**ESENCIA PORTABLES PHASE 2 PROJECT (re-bid)
Bid No. 2324-11**

**ADDENDUM NO. 1
June 18, 2024**

Subject: **ESENCIA K-8 SCHOOL
MODULAR CLASSROOMS**
Capistrano Unified School District

ADDENDUM No. 3

ITEM 01: SHEET A-1.1 SITE DEMO PLAN - ENLARGED

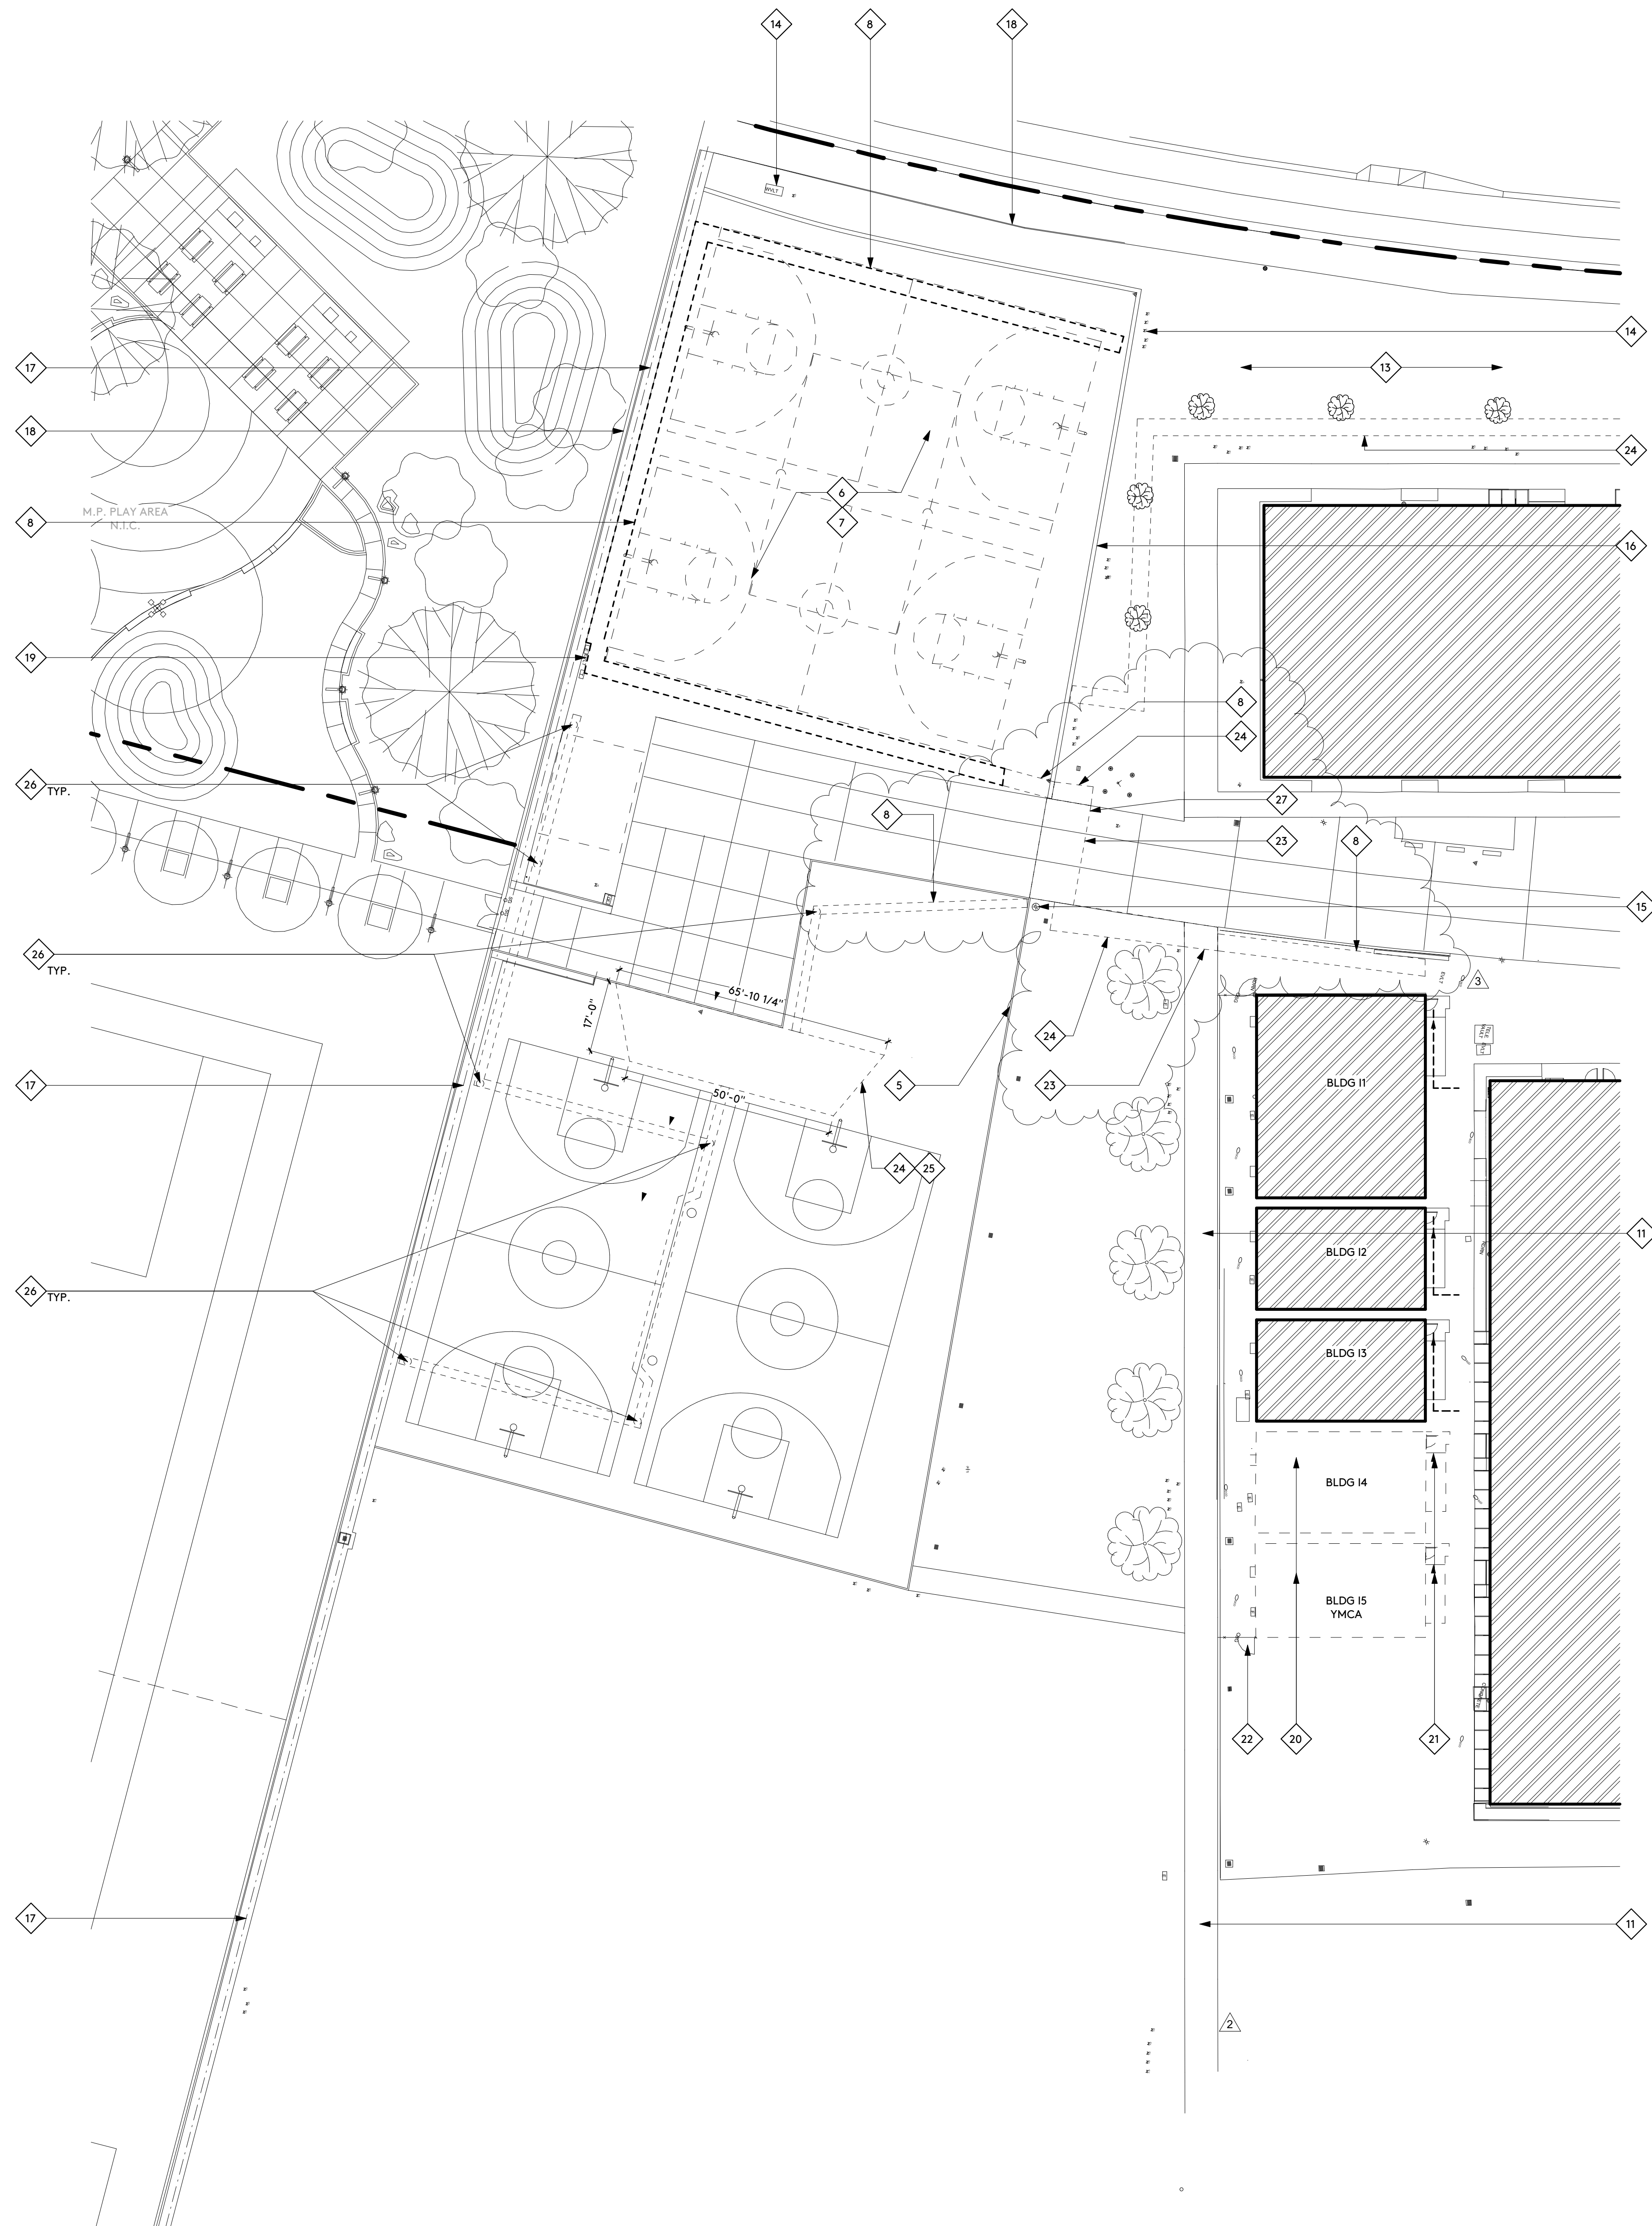
- A. At Demo Enlarged Plan Keynotes, add keynote #27 in it's entirety as shown.
- B. At Site Demo Plan – Enlarged, revise demolition of existing finish surfaces to coordinate with revised new electrical pathways.

- NOT USED
- NOT USED
- NOT USED
- NOT USED
- NOT USED
- REMOVE EXISTING SOIL AS REQUIRED FOR NEW PAVING SECTION. REFER TO CIVIL DRAWINGS.
- REMOVE EXISTING PLAY COURT EQUIPMENT AND SUPPORTS. REMOVE ALL BELOW-GRADE FOOTINGS, BACKFILL EXCAVATIONS AND PATCH WITH NEW PAVING.

- EXISTING ASPHALT PAVING SECTION TO BE REMOVED TO NATIVE SOIL. NATIVE SOIL TO BE EXCAVATED AS REQUIRED TO DEPTH OF NEW PAVING SECTION.
- REMOVE EXISTING PAVING AS REQUIRED TO INSTALL UNDERGROUND CONDUITS THAT POWER NEW FIXTURES. AT CONCRETE PAVING, REMOVE ENTIRE CONCRETE PANEL TO AVOID CUTS ON PANELS.

- NEW CONCRETE CUT TO ALIGN WITH EXISTING SCORE JOINT CUT. FIELD VERIFY.

ITEM 02: SHEET A-1.2 SITE PLAN - ENLARGED

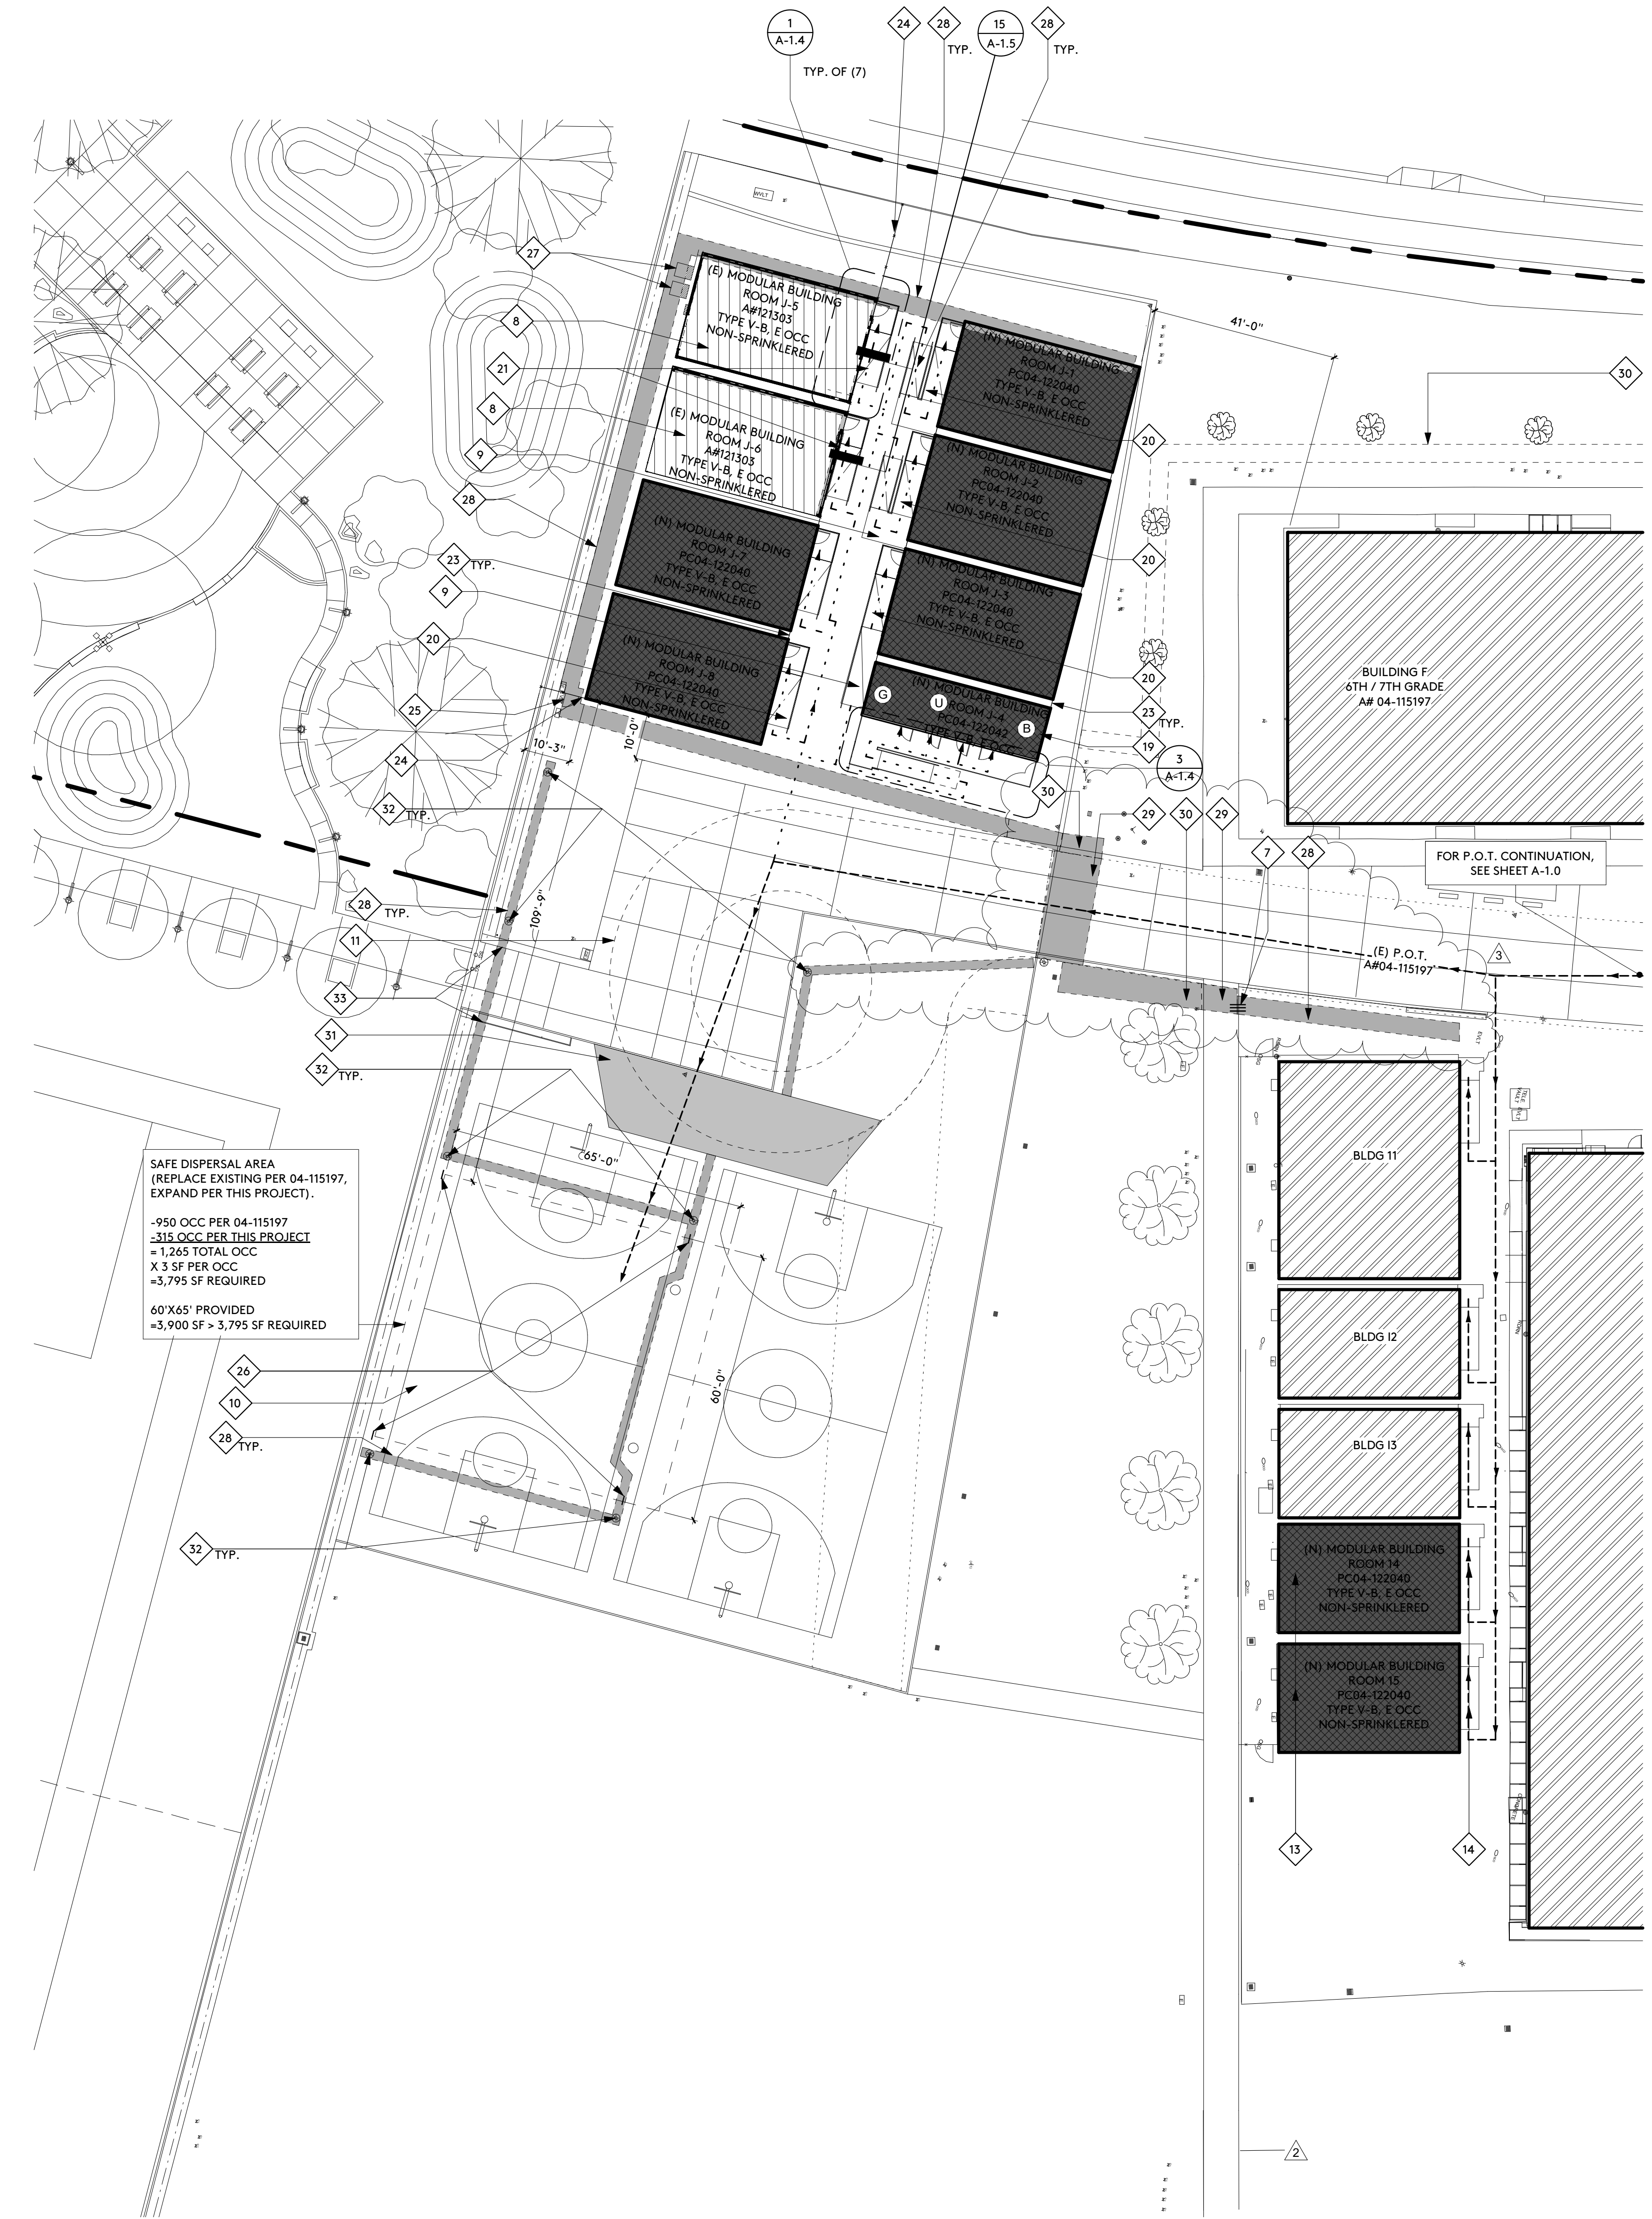
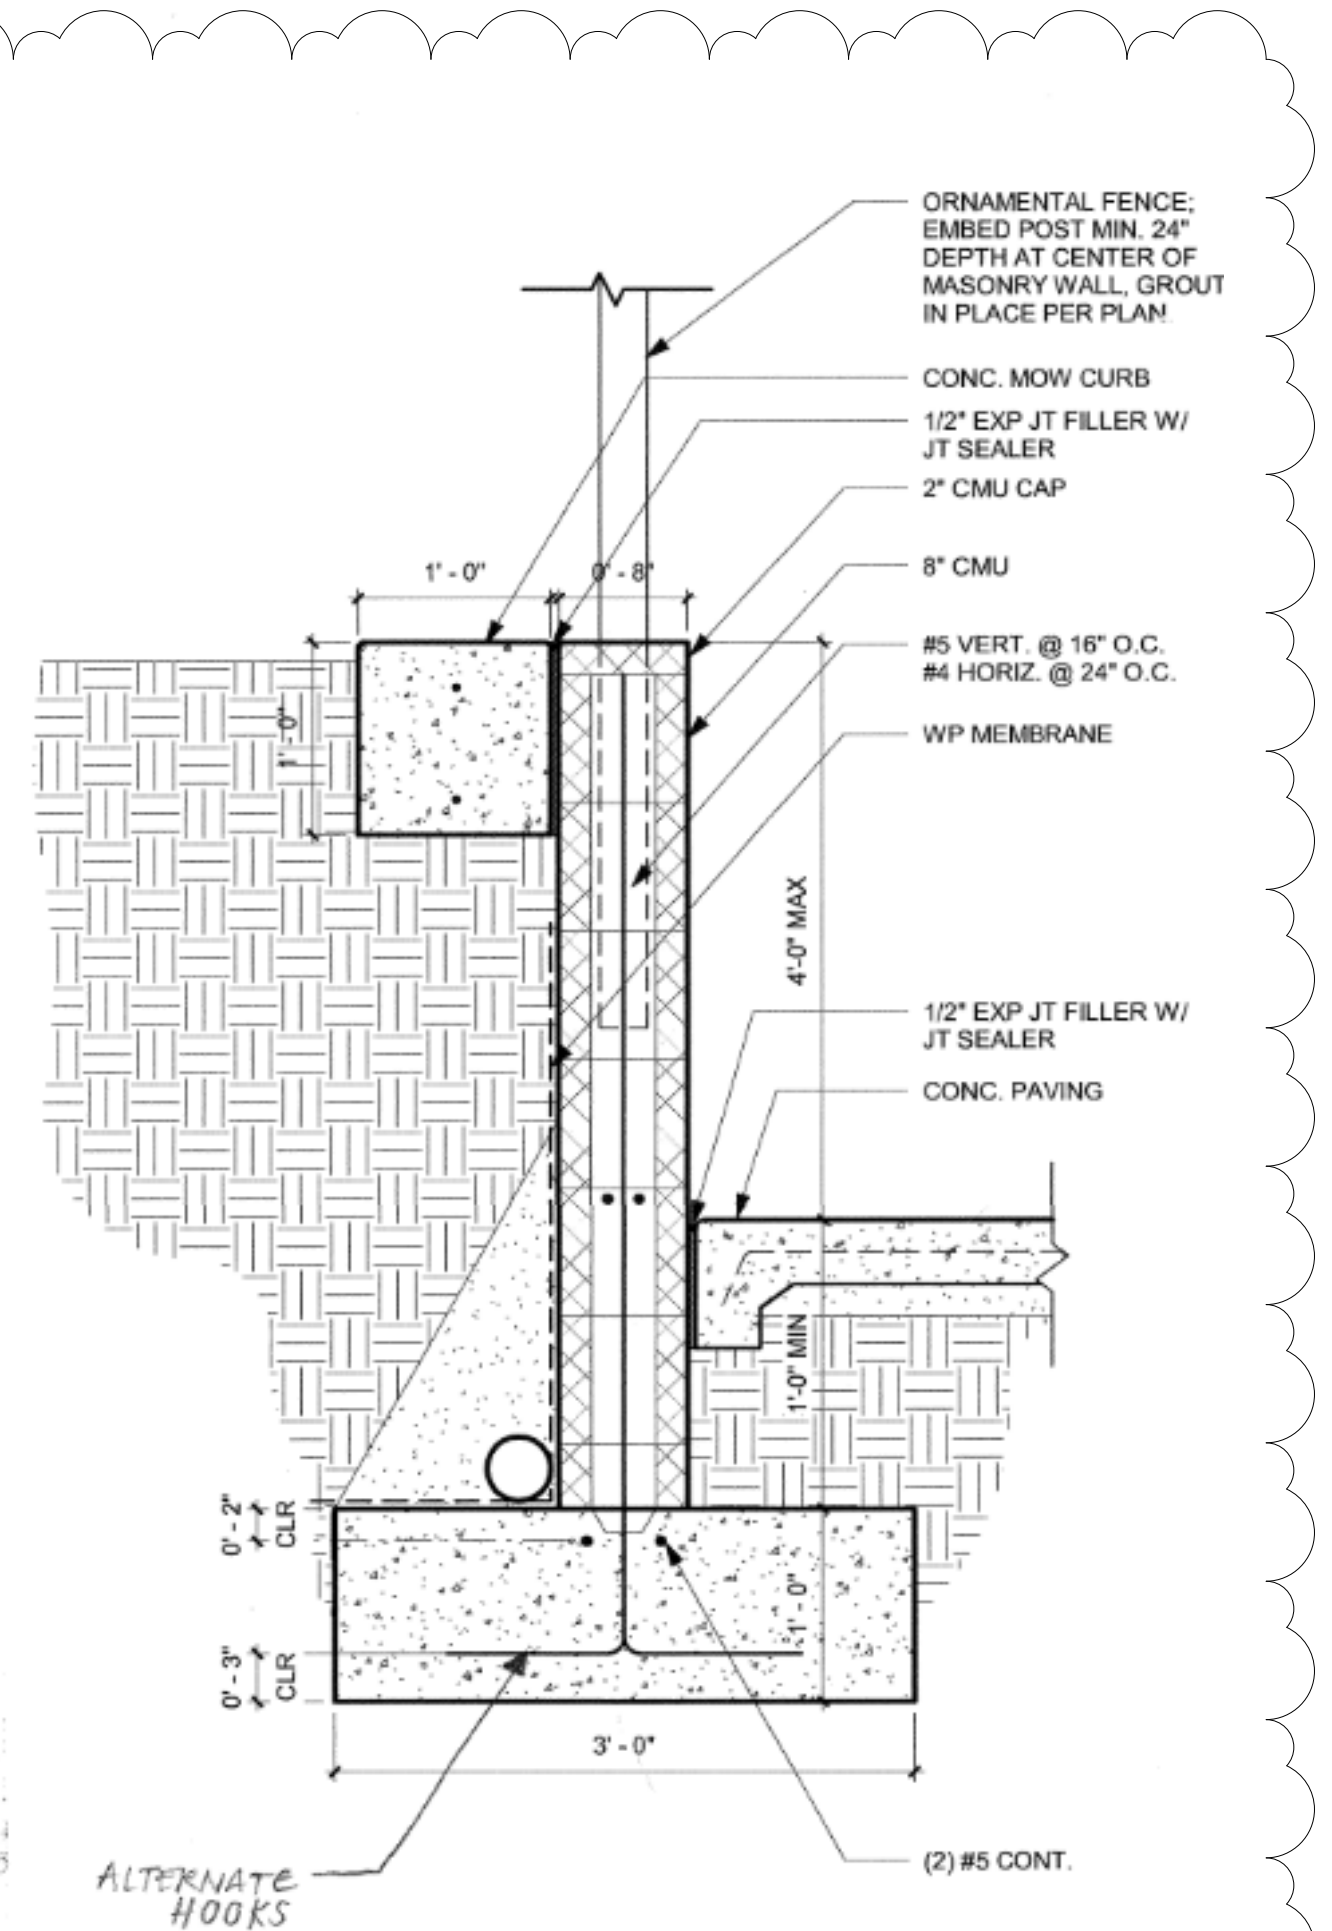
- A. At Enlarged Plan Keynotes, add keynote #7 in it's entirety as shown.
- B. At Site Plan – Enlarged, revise patching/replacement of existing finish surfaces to coordinate with revised new electrical pathways.
- C. Add detail 2 Existing Retaining Wall (A#04-115197) in its entirety for reference.

- NOT USED
- NOT USED
- NOT USED
- NOT USED
- NOT USED
- NOT USED
- ROUTE NEW ELECTRICAL CONDUITS BELOW EXISTING RETAINING WALL, REFER TO DETAIL 2/A-1.2 FOR REFERENCE. PROVIDE NEW CONCRETE ENCASEMENT, MIN. 12" COVER ALL SIDES, WHERE CONDUITS PASS BELOW EXISTING FOOTING.

(E) RETAINING WALL (A#04-115197) 2
(FOR REFERENCE ONLY)
